Vantage Mobility International

2017 Toyota Sienna Transmission Line Repositioning

Document Number: OP-W-0426

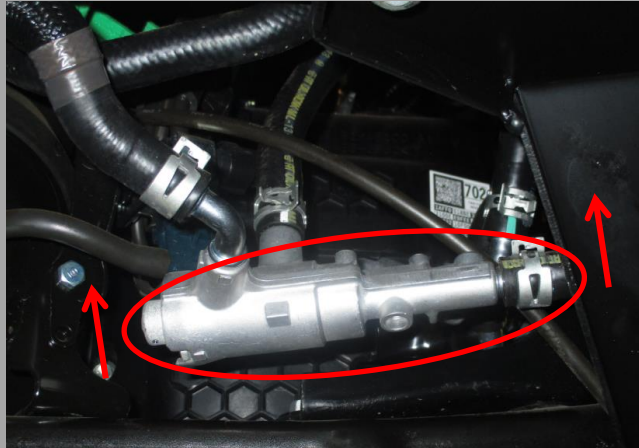
2. If visual inspection shows the transmission hose is less than 1/4" from the plate, remove the air dam clip using a flathead screwdriver.

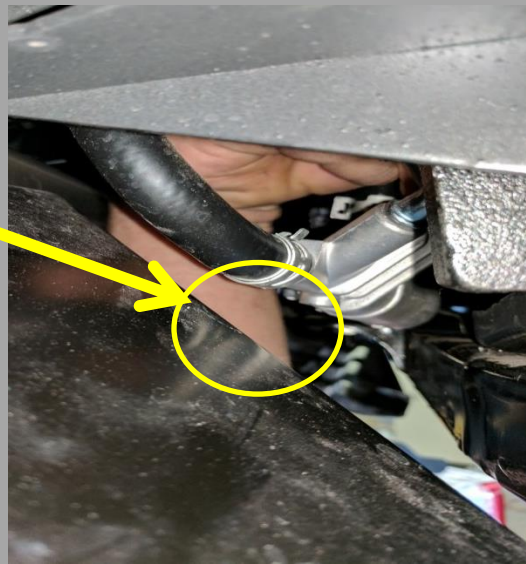
3. Using your hand or a small pry tool, push the transmission oil thermostat upwards, bending the mounting bracket and moving the transmission hose away from the shear plate.

4. Verify there is adequate (3/8" or more) clearance between the hose and the shear plate.
